ENVIRONMENTAL PROTECTION AGENCY**40 CFR PART 52**

[EPA-HQ-OAR-2011-0081; FRL-9487-8]

Final Response to Petition From New Jersey Regarding SO₂ Emissions From the Portland Generating Station**AGENCY:** Environmental Protection Agency (EPA).**ACTION:** Final rule.

Figure VI.C-1. Comparison of 2010 Emissions from Portland Units 1 and 2 with Allowable Emissions and Different Levels of Reduction from Allowable Emissions.

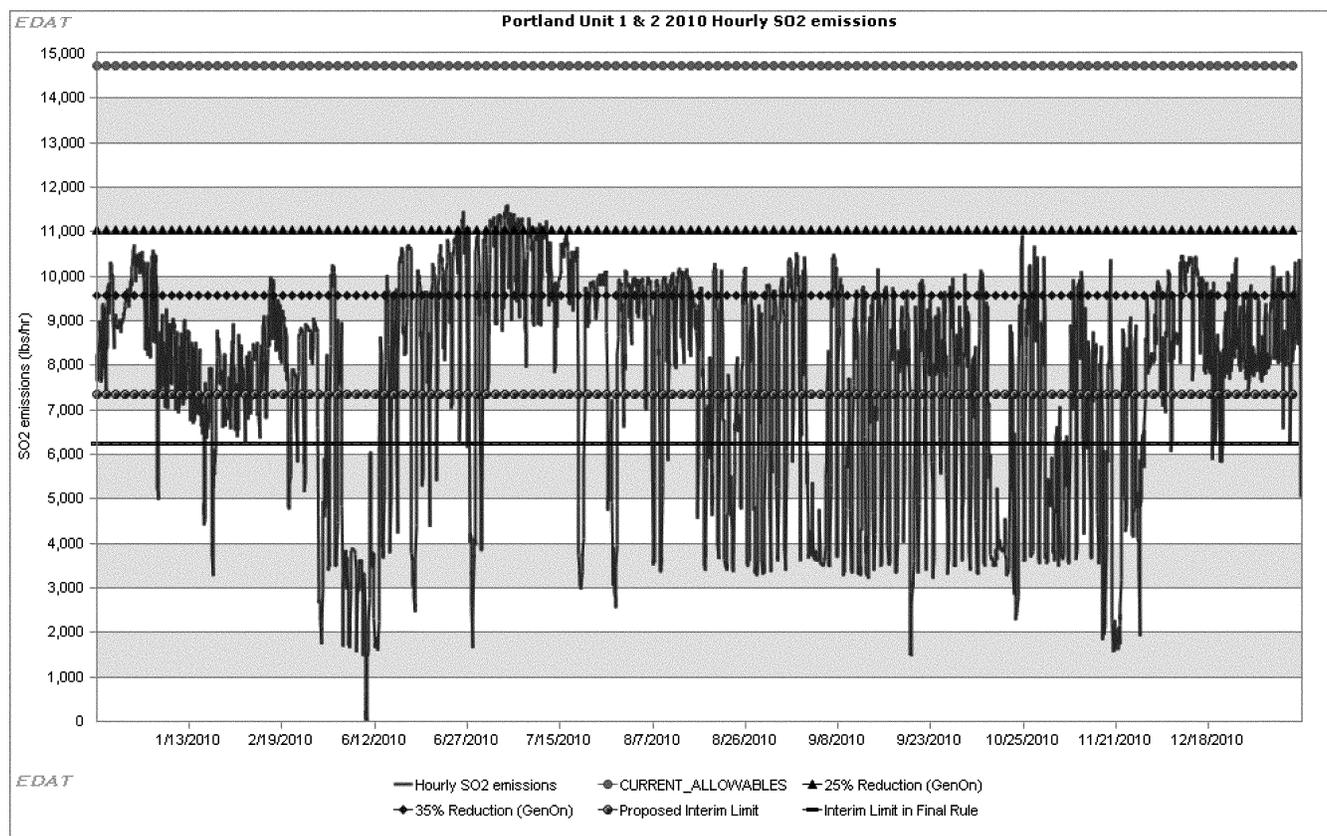
Comment: Based on the results of the test burn report, GenOn concluded that (1) Sustained unit operations using a blend of Northern and Central Appalachia coals sufficient to achieve a 25 percent reduction in allowable SO₂ emissions is achievable with a modest investment and an implementation schedule of 6 months, and (2) sustained unit operations using a blend of Northern and Central Appalachia coals to achieve a 35 percent reduction in allowable SO₂ emissions should be achievable with additional investments and an implementation schedule of 8 to 12 months after GenOn has established an operational record and completed equipment performance evaluations at the 25 percent reduction blend level, and any necessary permits are acquired.

Response: The EPA evaluated the suggested interim reductions in the GenOn test burn report. The EPA concluded that based upon this evaluation, these targets are significant underestimates of the readily available interim emissions reductions, represent very minimal reductions from current operations, and are inconsistent with the results of the test burn.

Figure VI.C-1 shows the hourly SO₂ emissions for all of 2010 at Portland, shown as the sum of emissions from units 1 and 2. For the EPA (and GenOn's) air quality analysis, the assumed allowable emissions rates for units 1 and 2 were 5,820 lb/hr and 8,900 lb/hr, respectively, resulting in a total allowable rate of 14,720 lb/hour. A 25

percent reduction from this amount, that is a 25 percent reduction from current allowable, thus becomes 11,040 lb/hr. As shown in Figure VI.C-1, during 2010, Portland's hourly emissions exceeded 75 percent of

allowable emissions only rarely. Accordingly, a 25 percent reduction in allowable emissions effectively represents status quo operations. A 35 percent reduction in allowable emissions, or 9,568 lb/hr, would require

at most a roughly 15 percent reduction in current emissions. EPA continues to believe that the facility can make much more significant reductions in line with the final interim limits within a year.
